Service Bulletin

PRELIMINARY INFORMATION

Subject: Burning Odor on Volts When Operating in Extended Range, Hold, or Mountain Modes

Models: 2016 Chevrolet Volt

3) Foam installed folded over, contacting the line

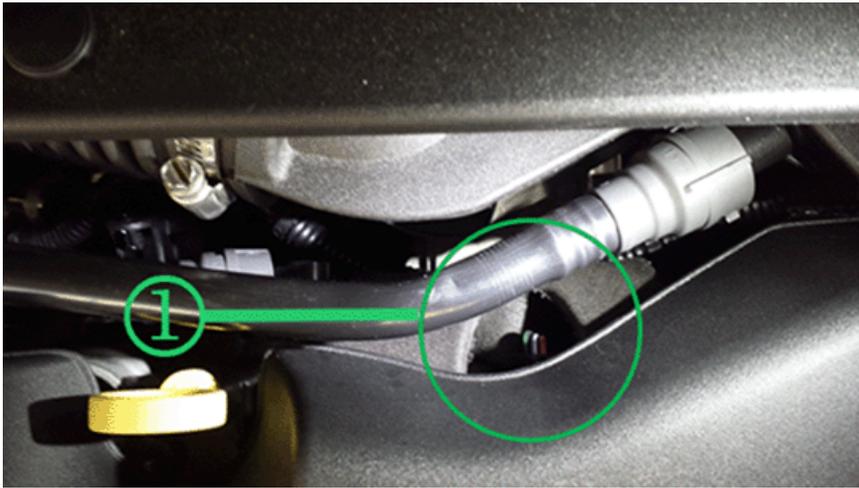
Engine Cover Foam not installed correctly

2) Foam is Deformed from heat

1) Cover and foam installed Correctly

Please inspect the Engine cover and Compare to the pictures to see if the foam is folded.

- 1) If the Foam is deformed then replace the cover.
- 2) If a burning odor was found replace the cabin filter.
